TECHNICAL SERVICE BULLETIN			
ISSUE DATE:	07/10/18	TSB NUMBER:	TSB-198
HAZARD / URGENCY RATING			
X	DANGER - Physical harm is possible if TSB is not observed or followed		
X	WARNING - Equipment damage is possible if TSB is not observed or followed		
X	CAUTION - Essential issue affecting operation, service, parts or installation		
	INFORMATIONAL - Advisory which may be of interest

ALL RAFNA R-460 REAR RAILGEAR BEING INSTALLED ON A 2017/2018 FORD F450/F550 GAS OR DIESEL WITH A METAL FUEL TANK CRADLE.

FORD MID PRODUCTION HAS MADE A CHANGE TO THE VEHICLE'S FUEL TANK CRADLE CAUSING INTERFERENCE WHEN INSTALLING THE R-460 REAR RAILGEAR ON THE VEHICLE.

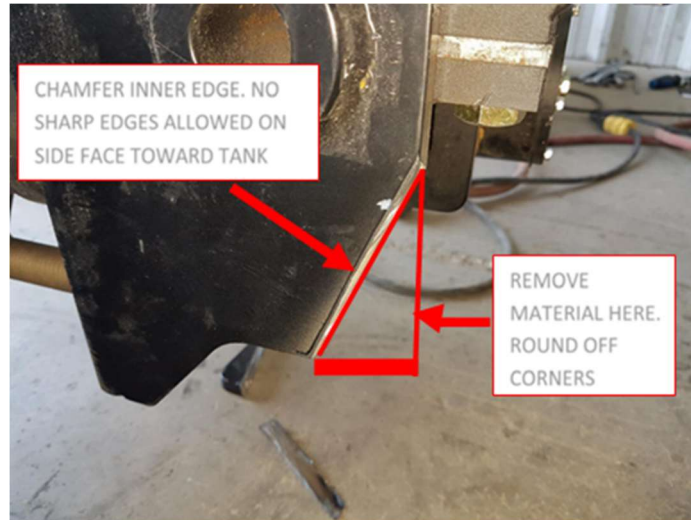
1. THE DRIVER'S SIDE PIVOT BOX COMES IN CONTACT WITH THE TANK CRADLE.

TO ADDRESS THIS, THE FOLLOWING MODIFICATIONS NEED TO BE MADE TO THE ROTATING ASSEMBLY:

- REMOVE CORNER OF INNER DRIVER'S SIDE BRACKET ON THE ROTATING ASSEMBLY AS SHOWN. APPROXIMATELY 3" X 1 1/2". THIS IS A REFERENCE, AND MAY BE DIFFERENT DEPENDING HOW THE RAIL GEAR IS CENTERED. THERE SHOULD BE NO SHARP EDGES AFTER MODIFICATIONS. AVOID CUTTING INTO THE WELDS WHEN POSSIBLE.
- MODIFICATIONS TO THE TANK CRADLE ARE ALSO REQUIRED TO ENSURE PROPER CLEARANCE AND FUNCTION. LOCATE WHERE THE RAIL GEAR IS TO BE MOUNTED AND WILL SIT WHILE ROTATED IN THE ROAD POSITION. THERE IS APPROXIMATELY 3/4" FROM THE INSIDE OF THE CRADLE TO THE OUTSIDE OF THE FUEL TANK. MARK OFF THE AREA ON THE TANK CRADLE AND LIGHTLY WORK THE CRADLE WITH A HAMMER UNTIL THERE IS PROPER CLEARANCE FOR THE ROTATION OF THE RAIL GEAR. THIS SHOULD BE CHECKED AND WORKED MULTIPLE TIMES UNTIL CLEARANCE IS ACHIEVED.

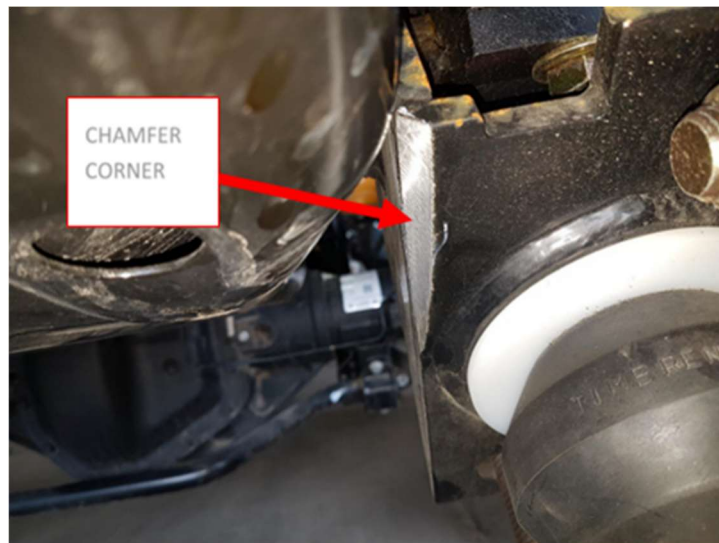
2. THE PASSENGER'S SIDE PIVOT BOX ALSO COMES IN CONTACT WITH THE TANK CRADLE.
G&B Specialties Inc. 535 West 3rd Street, Berwick, PA, USA Tel: 1-570-752-5901 Fax: (570) 752-6397

TO ADDRESS THIS, THE FOLLOWING MODIFICATIONS NEED TO BE MADE TO THE ROTATING ASSEMBLY:

- PUT A 45° CHAMFER ON INSIDE CORNER OF THE PASSENGER SIDE ROTATING ASSEMBLY. THE LENGTH WILL VARY DEPENDING ON HOW THE GEAR IS CENTERED.
